FINAL DRAFT MINUTES

March 17, 2022 Standards Committee Meeting

E 801-TCDV, E 801-TCLC, E 801-TCSC, E 801-TCTC series (proposed revised draft)

INDIANA DEPARTMENT OF TRANSPORTATION	
CHANNELIZING DEVICE USAGE	
SEPTEMBER 2022	
STANDARD DRAWING NO.	E 801-TCDV-04
DESIGN STANDARDS ENGINEER	DATE
CHIEF ENGINEER	DATE

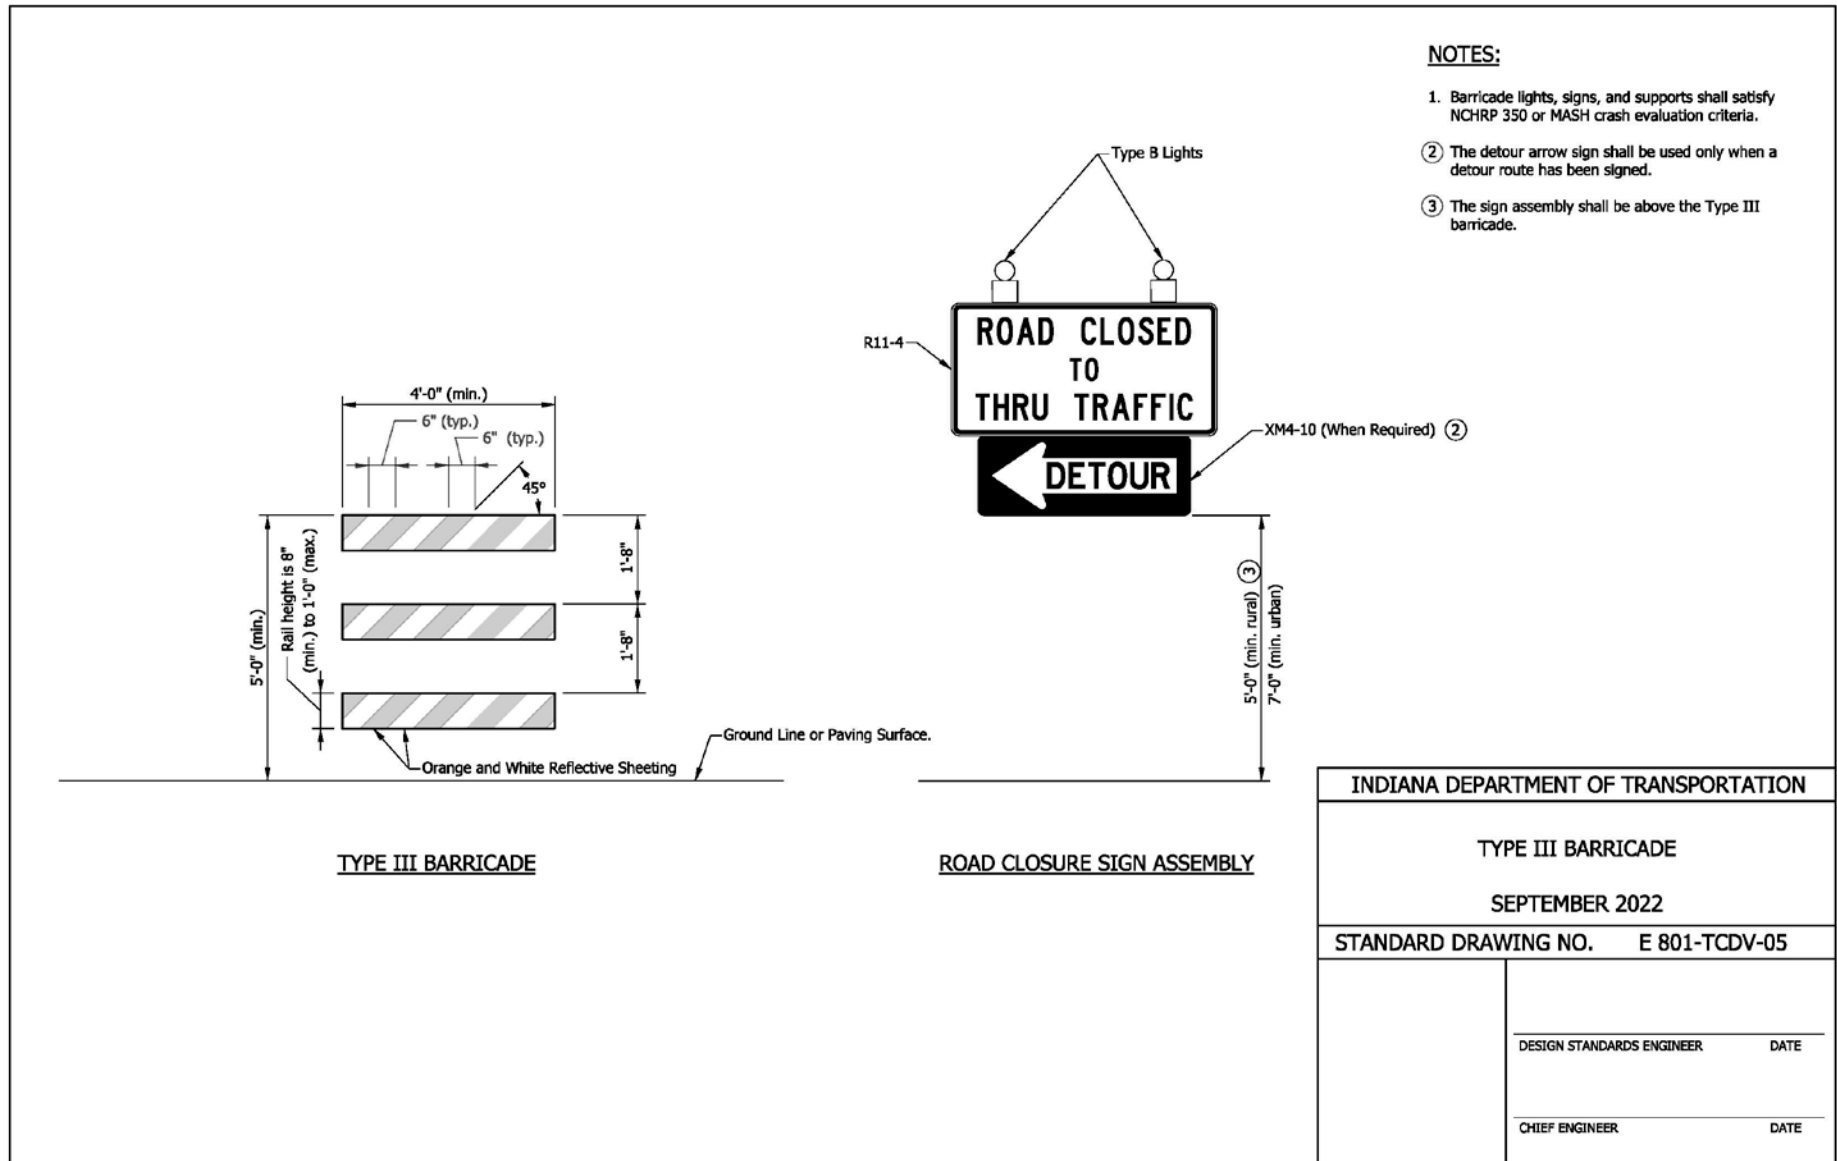
With regard to drawing 801-tcdv-04, Mr. Koch asked if in order to reinforce a new concept, should the table header be revised to include the less than 10 ft effective lane width language? Mr. Boruff concurred with this and stated that the wording in the column headers currently referring to “where space is limited” should be changed to “where the effective lane width is less than 10 ft.”

E 503-BATJ-02 TERMINAL JOINT, TYPE PCCP (with markups)

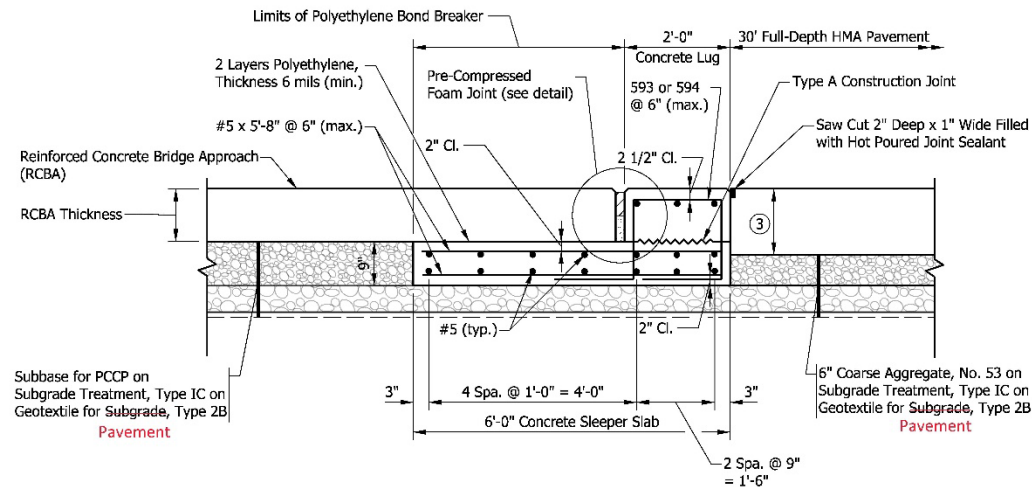
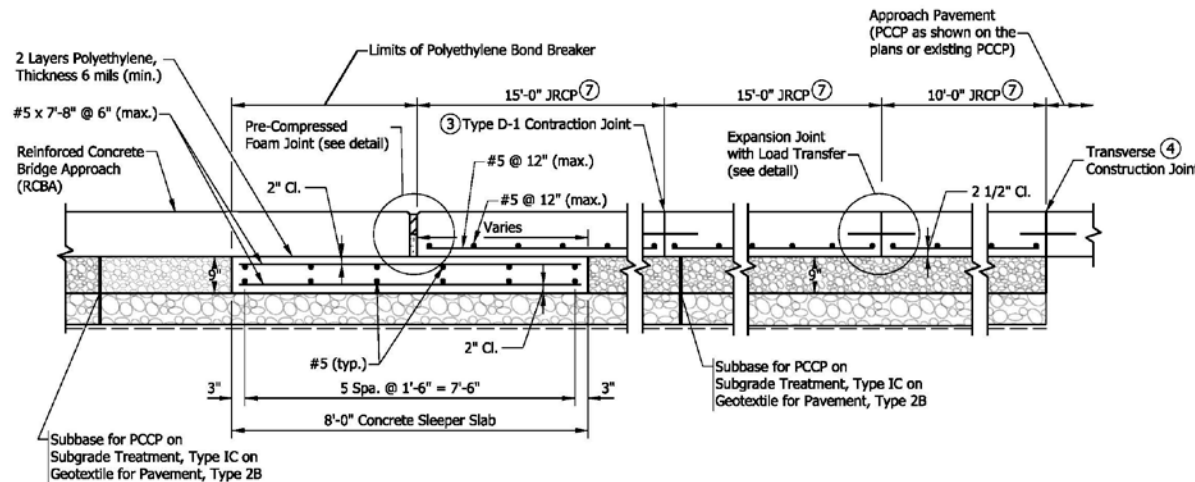
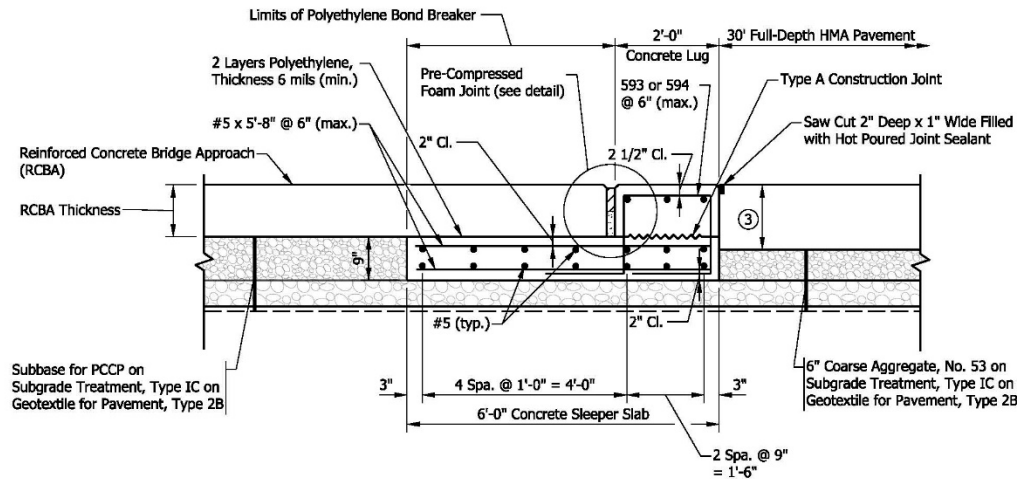
Mr. Orton proposed to revise Standard Drawings E 609-RCBA-04, E 503-BATJ-02 and E 503-BATJ-03, as shown.
